Re: PROJECT: Uptown240
ADDRESS: 240 Lake Dillon Drive, Dillon, CO 80435
PERMIT NUMBER: Planning Case Number 2018.001

Architect Respondent: Studio PBA, Inc
Kathy Parker, Project Architect
kparker@studiopba.com
720-376-6845

Below please find narrative responses to your comments dated March 28, 2018 on the above referenced project. Thank you for your review.

SHEET
 C-4

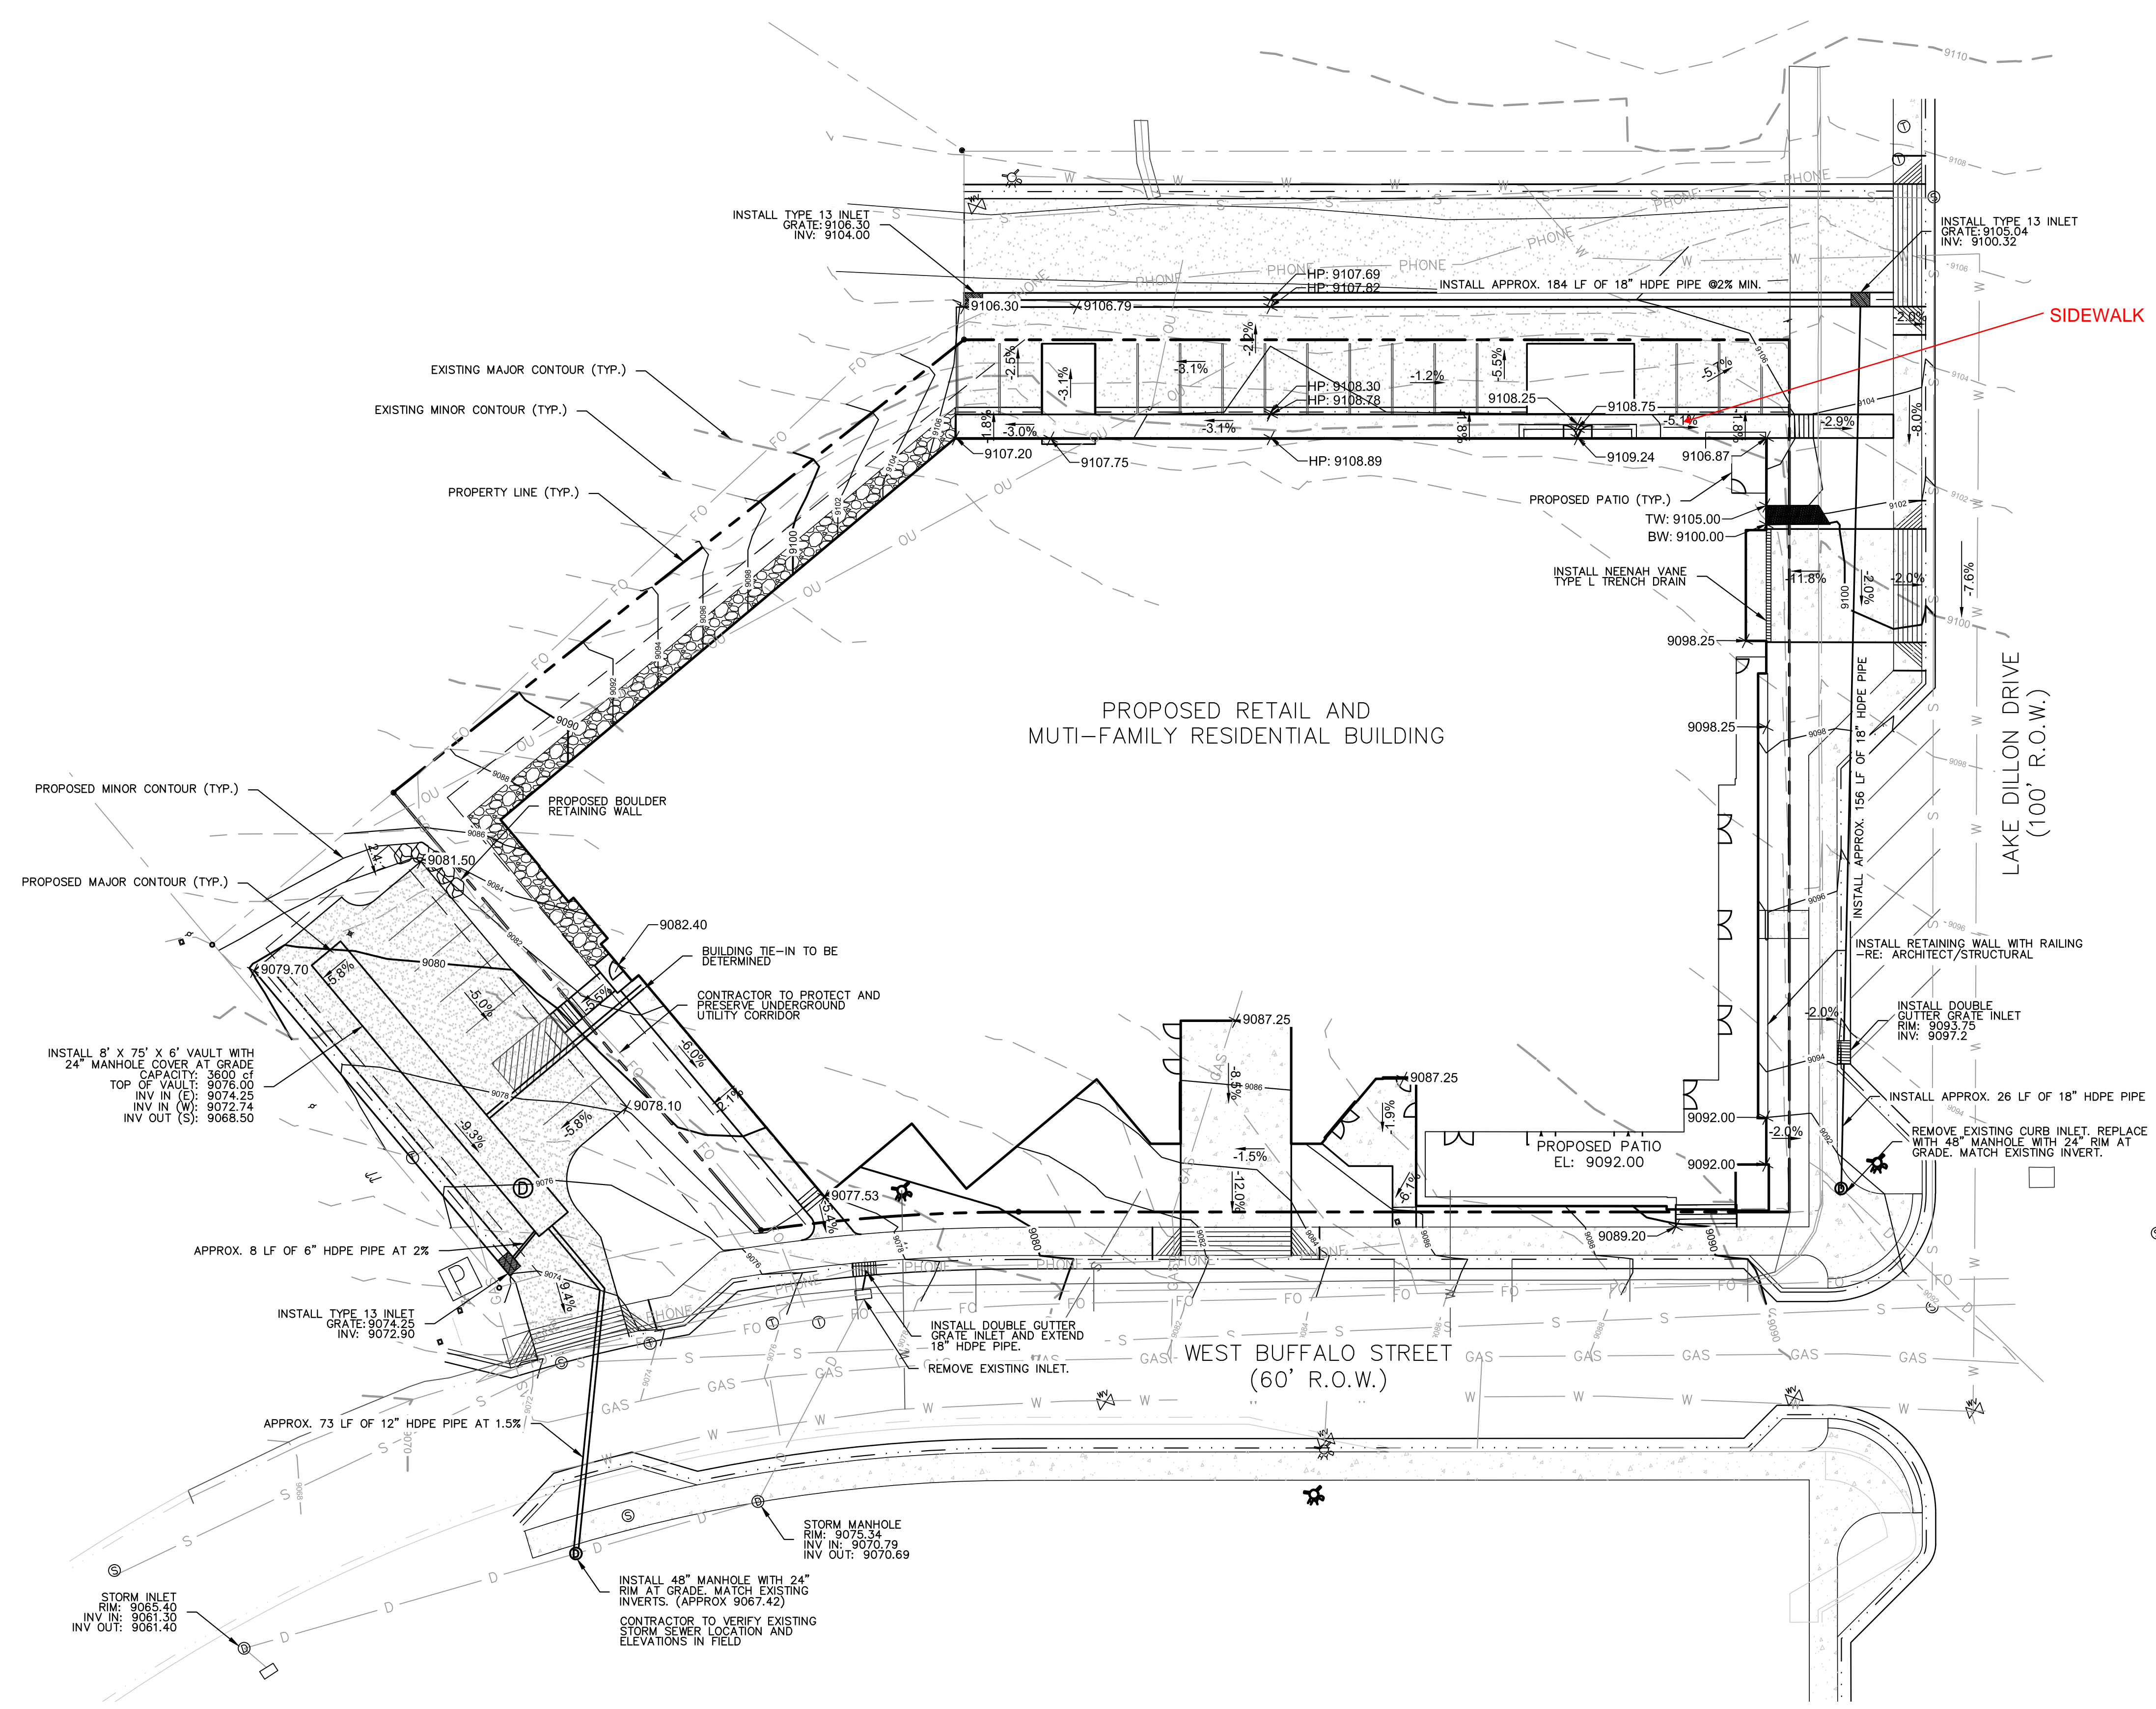
3. Provide an approved pathway/sidewalk on the North side of the structure.
 - a. RESPONSE: See attached Sheet C4 Grading Plan which documents a sidewalk leading from the Lake Dillon Drive public sidewalk, along the north side of the building, separate from the 40' public ROW. This sidewalk is 5' wide, and provides pedestrian and fire department access to the building entrance/egress on Level 3.
